3. HP MEMO - Deering Oaks - Public Infrastructure Alterations

**LEGAL ADVERTISEMENT
HISTORIC PRESERVATION BOARD
CITY OF PORTLAND
Public comments are taken at all meetings.**

On **Wednesday, February 15, 2017** at **5:00** p.m., the Portland Historic Preservation Board will meet in Room 209 of City Hall to review the following items. (Public comments are taken at all meetings):

PARKING LOT LAYOUT PLAN

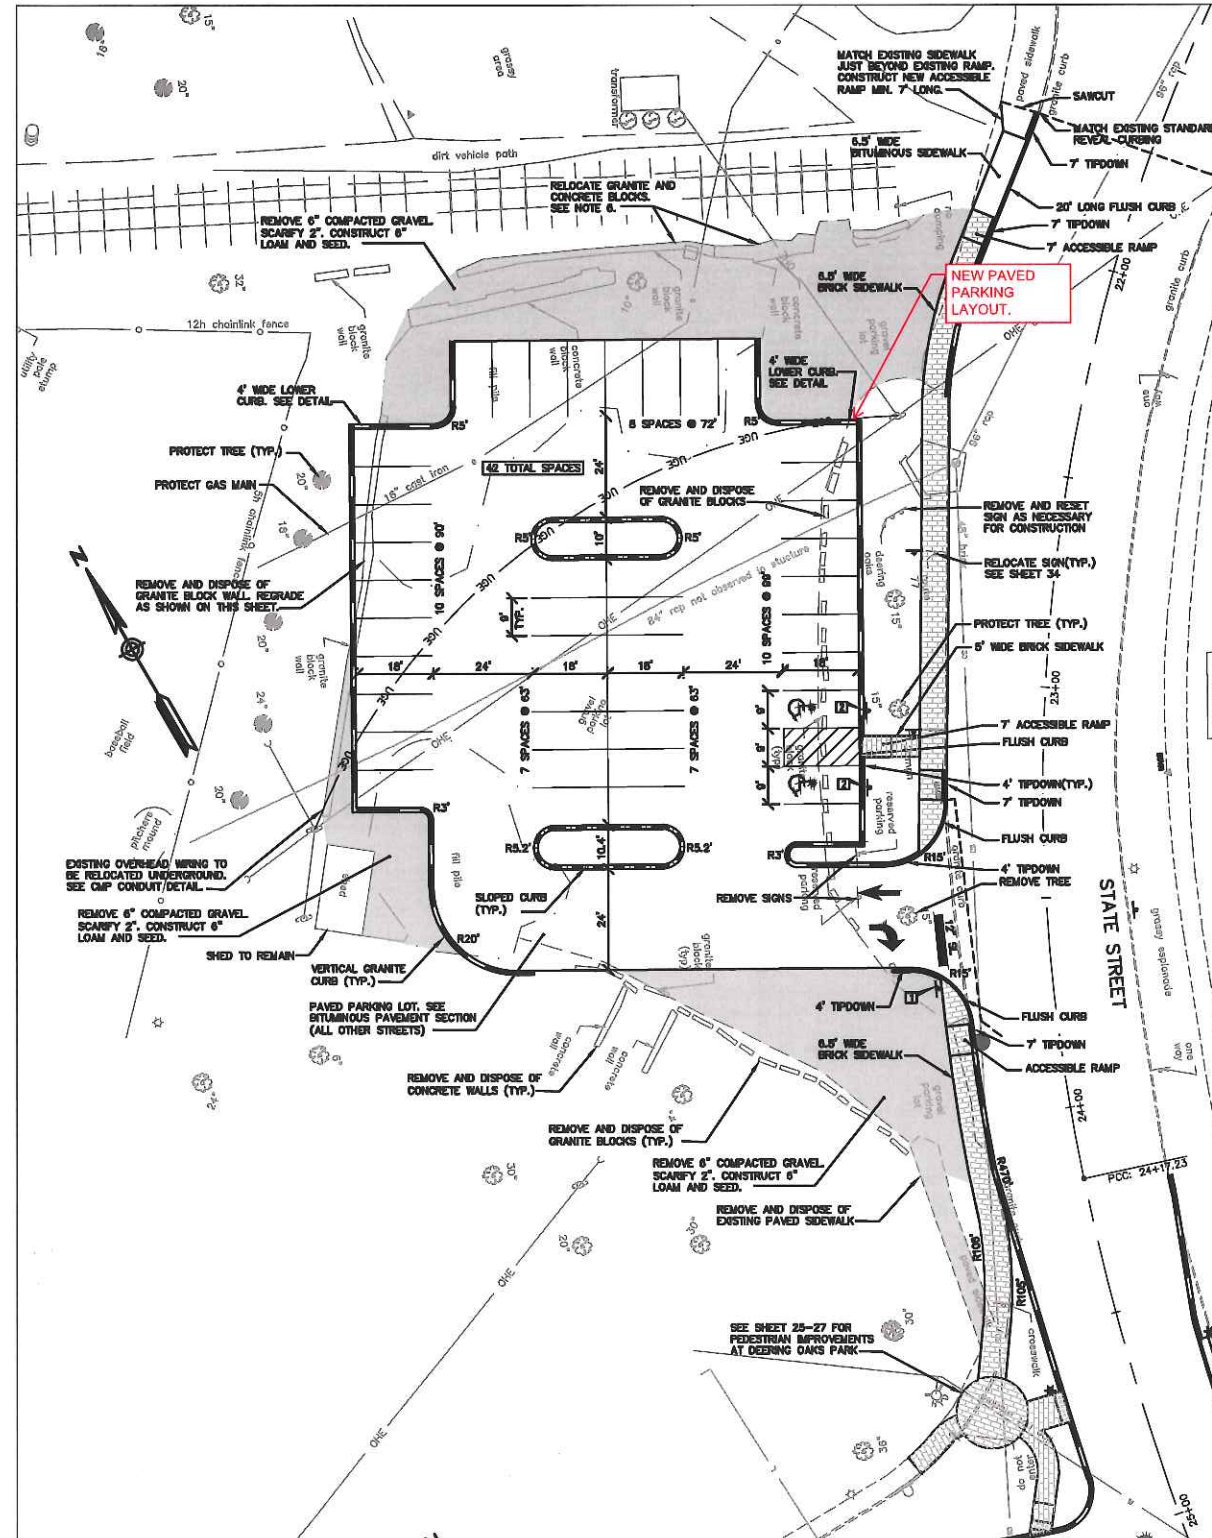
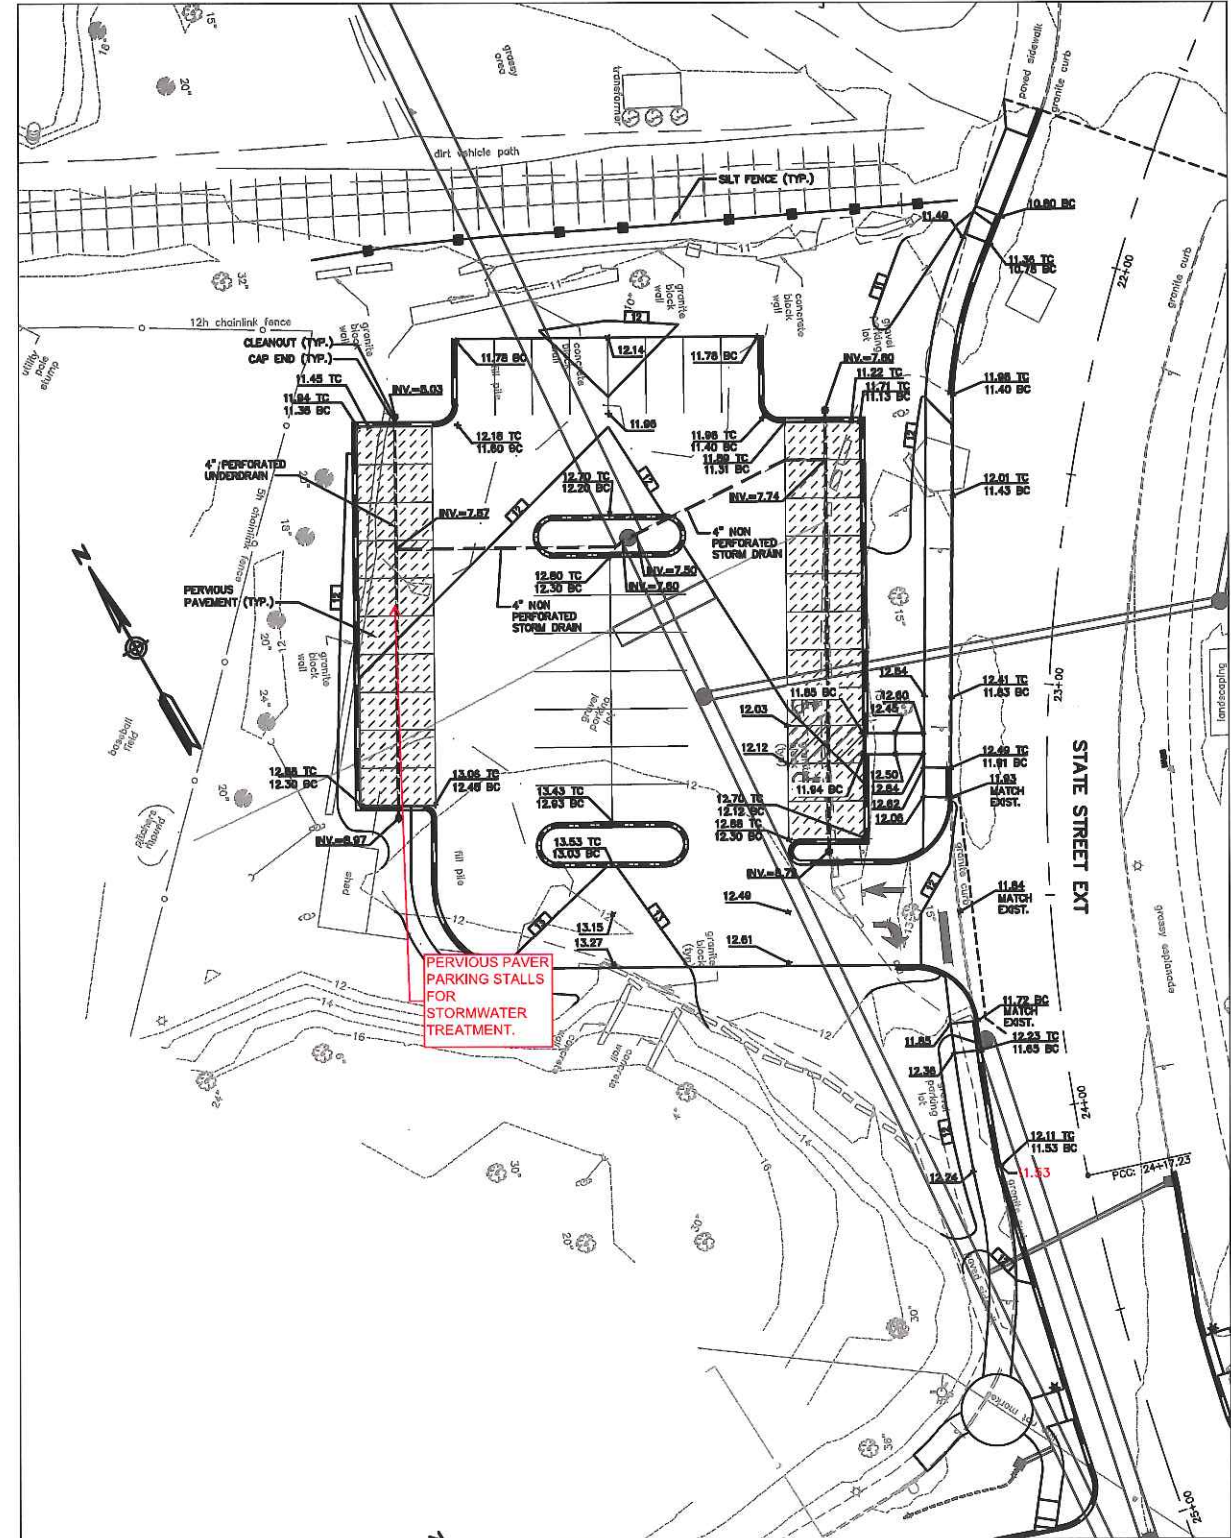
- Rehabilitation of the existing gravel parking lot near the Castle. (See Sheet 38.) Project calls for repaving with a combination of asphalt for circulation areas and permeable pavers for parking stalls. Two islands are shown within the lot, but it is not clear whether they are to have trees or other landscaping. As part of the project, the northern entrance to the parking lot (closest to Forest Ave) will be closed and the esplanade and brick sidewalk along the street edge continued. The sidewalk will also be extended toward the Castle. The southern entrance to the parking lot will be narrowed and better defined. Overhead power lines will be buried.

STATE STREET & MARGINAL WAY
SEWER SEPARATION
DEERING OAKS PARKING LOT
SITE, GRADING & DRAINAGE PLAN

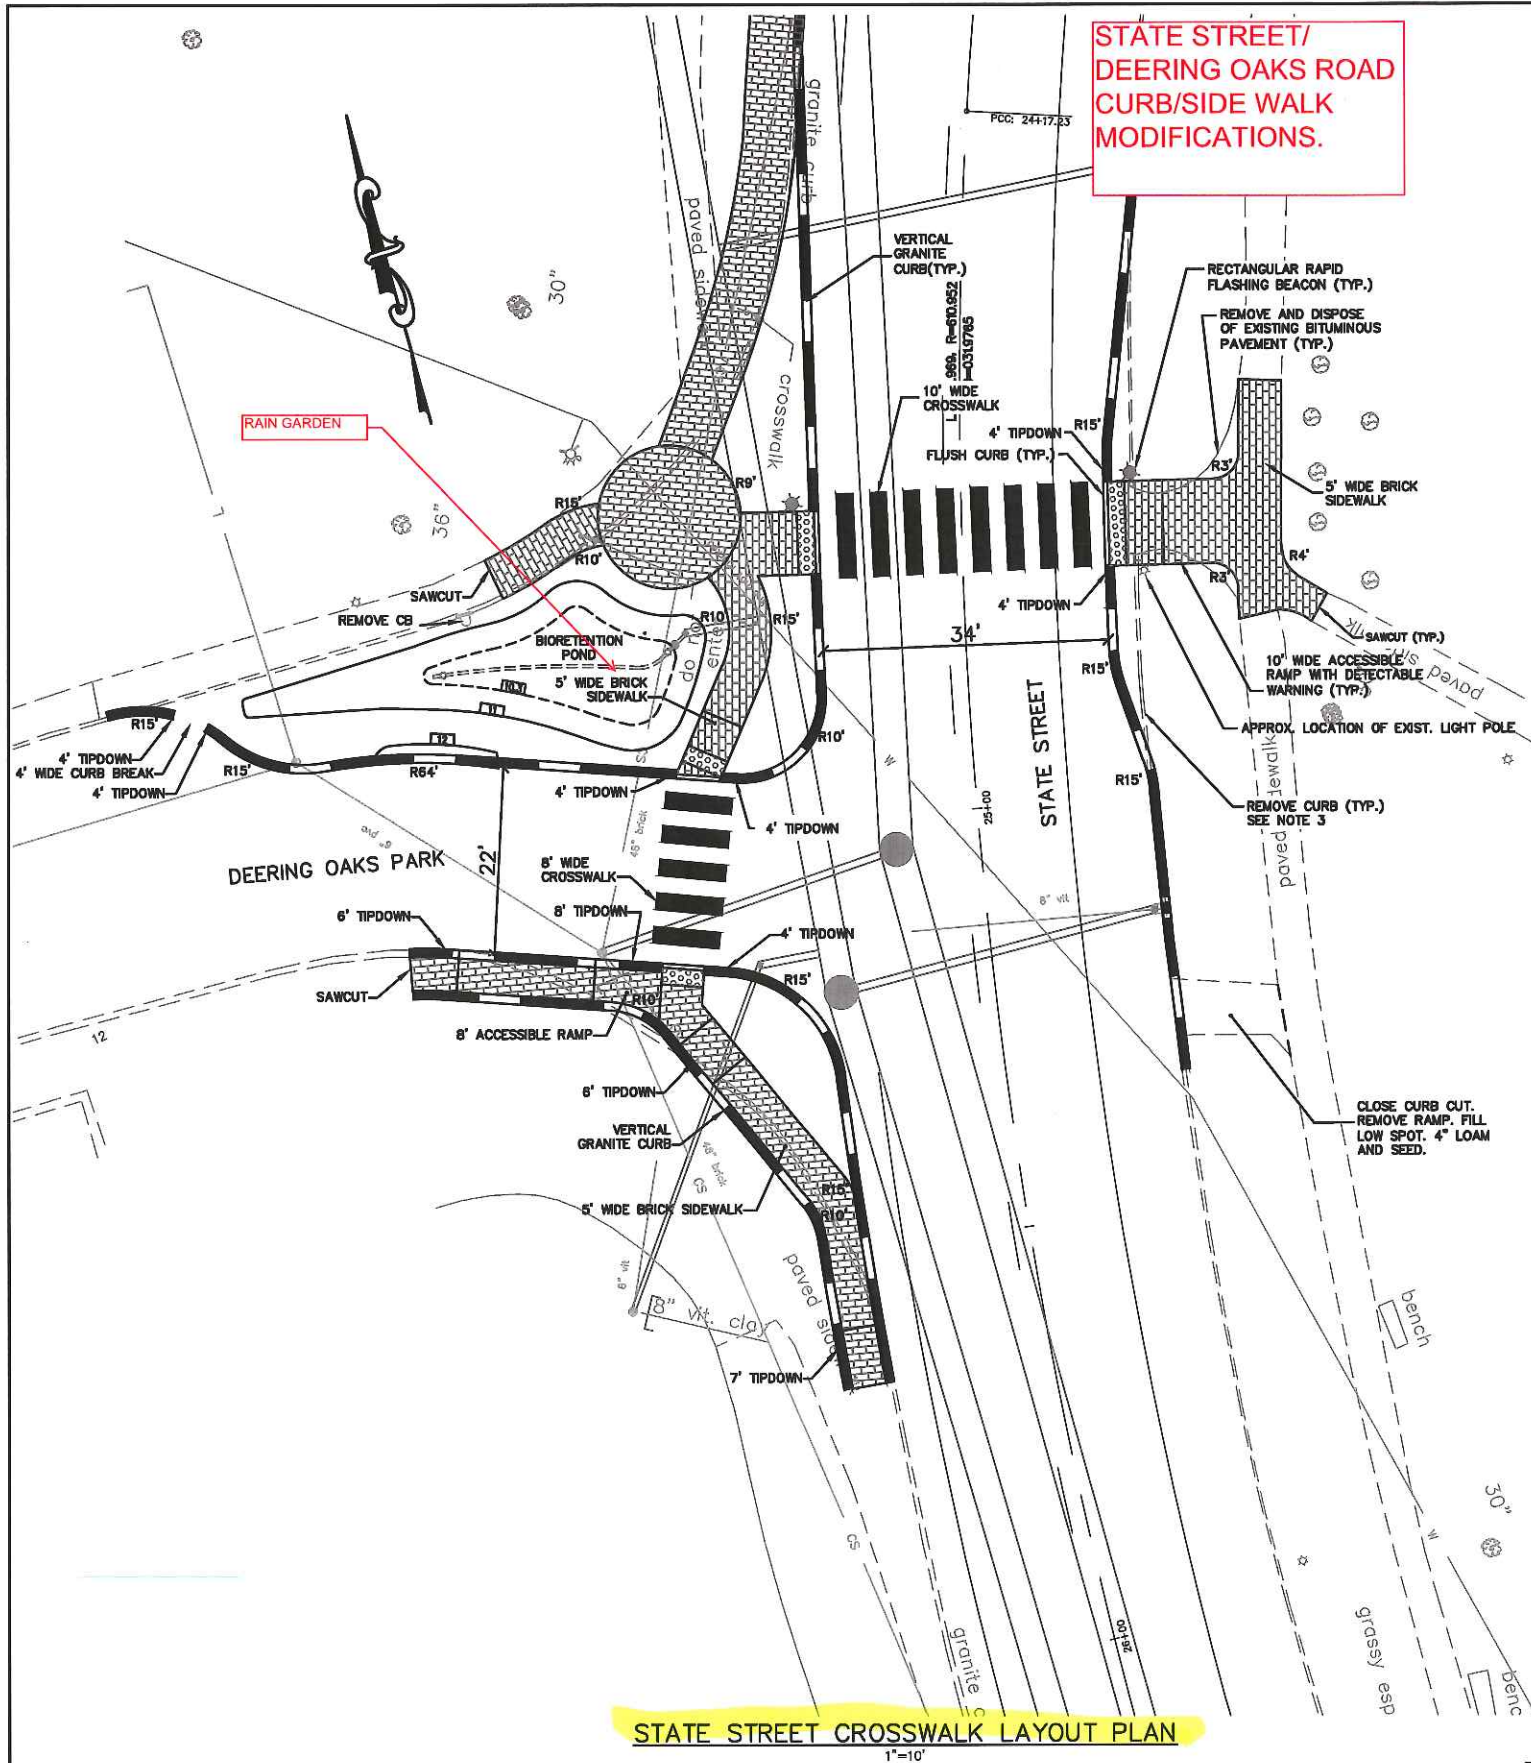
- Reconfiguration of State Street/Tennis Court Road intersection. (See Sheet 25.) The project calls for significantly narrowing Tennis Court Road where it meets State. (See dashed lines for current road edges.) As well, crosswalked will be defined, ADA tip-downs will be introduced and the sidewalk will be extended on either side of the Tennis Court Road at the intersection.

STATE STREET/SHERMAN STREET CROSSWALK LAYOUT PLAN

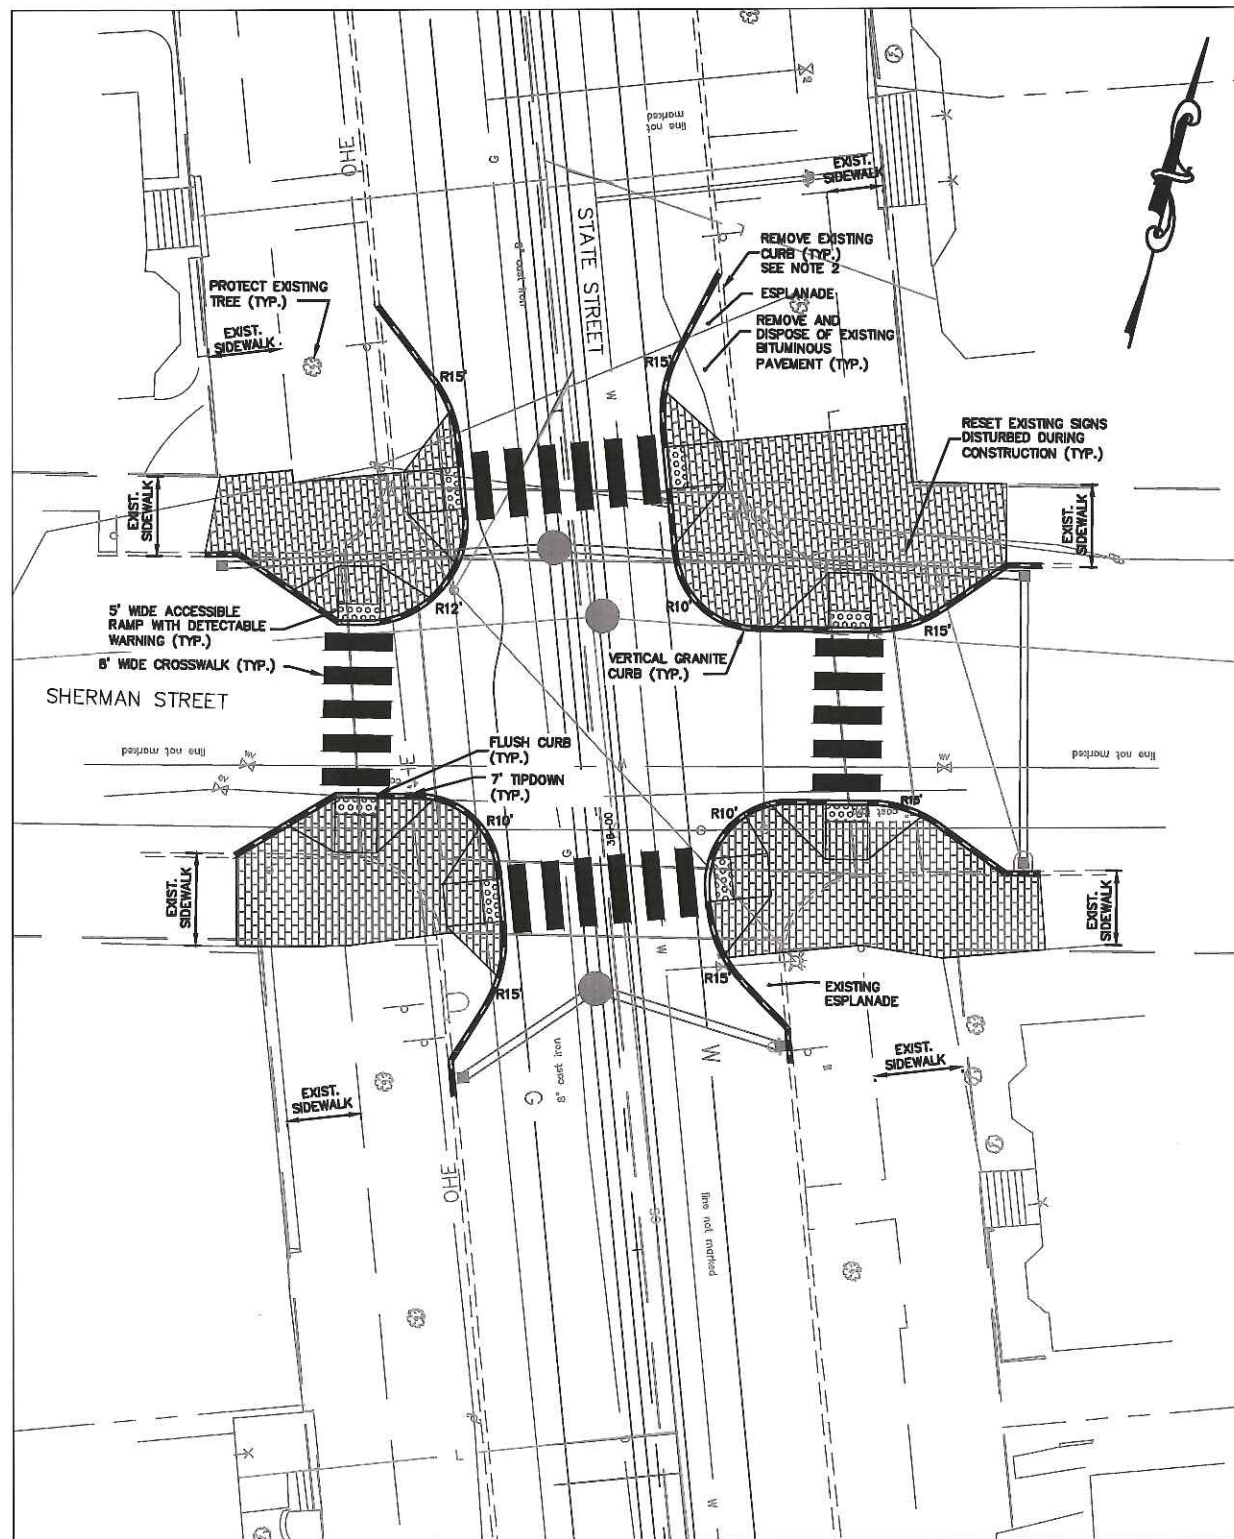
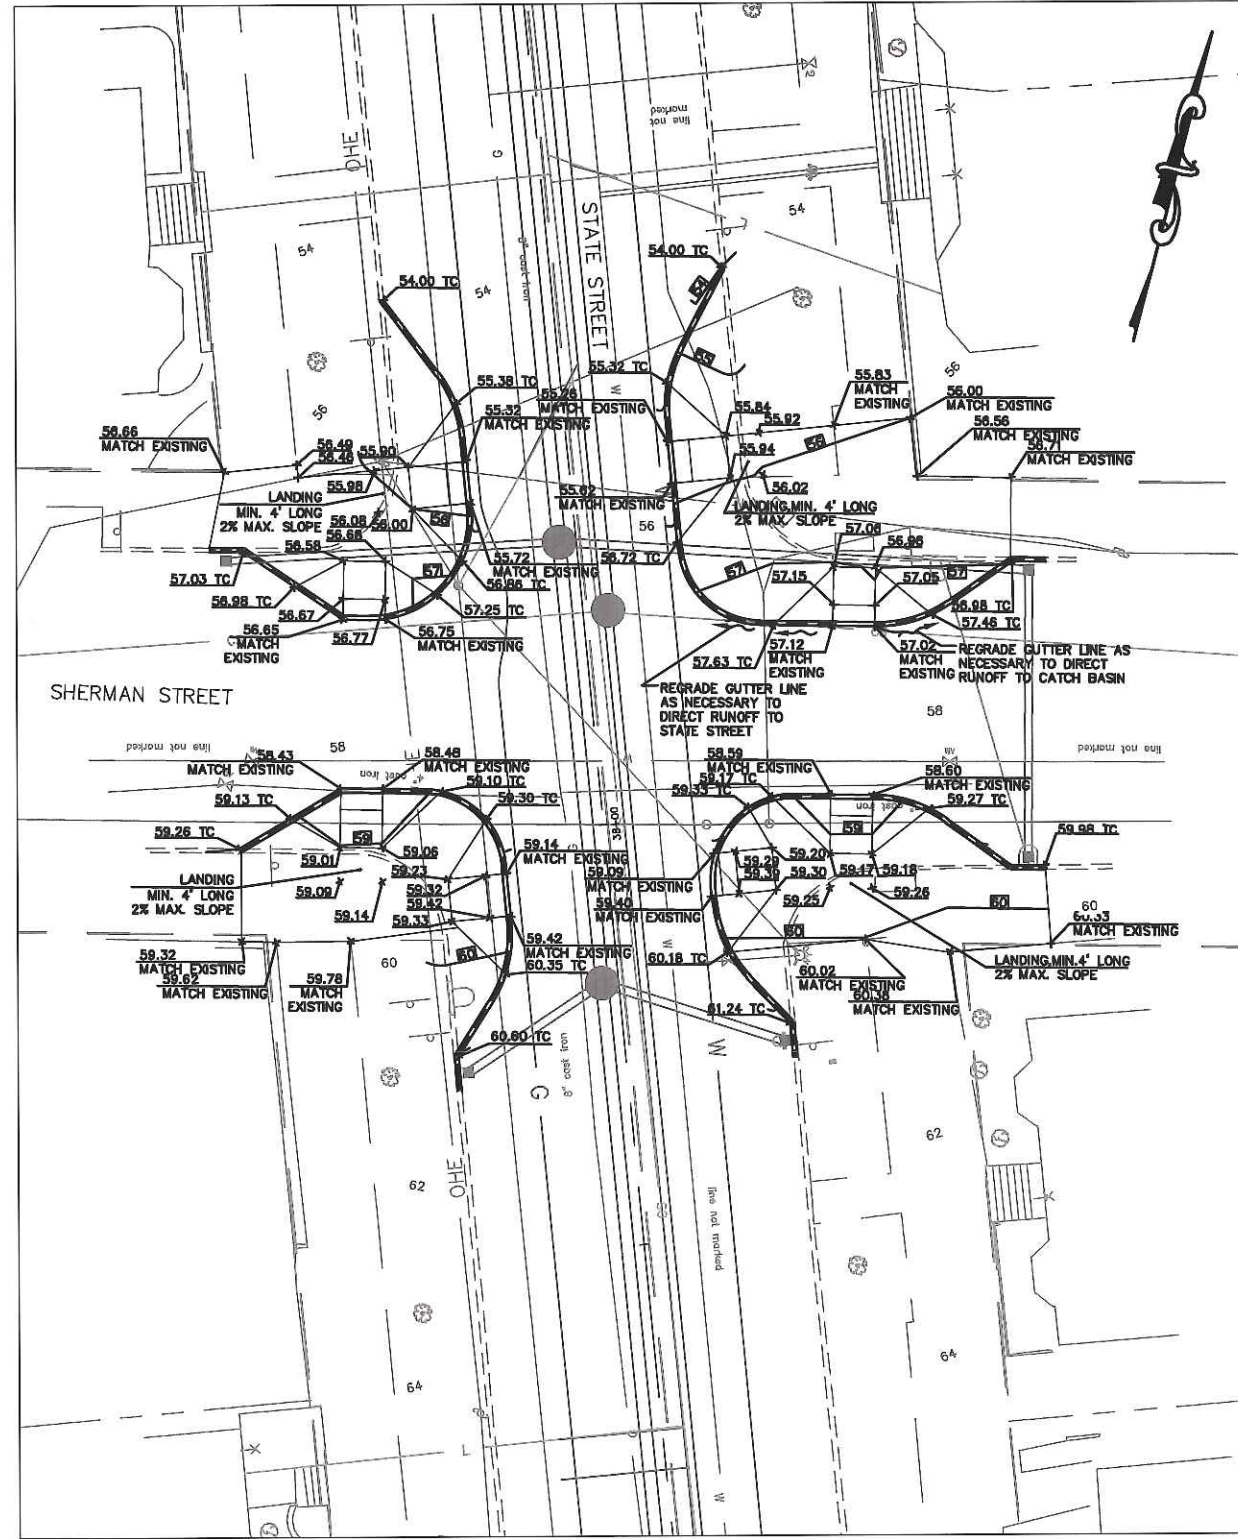
As with the modified intersection near the Deering Oaks Castle, to retain State Street’s historic streetscape character, the proposed changes to the State/Grant and State/Sherman Street intersections should not appear unduly forced. (This section of State Street is also located within a historic district, in this case the Deering Street Historic District.) Staff suggests that the transitions in roadway width be made more gradual and that the widened sidewalk areas at the intersections be less exaggerated.
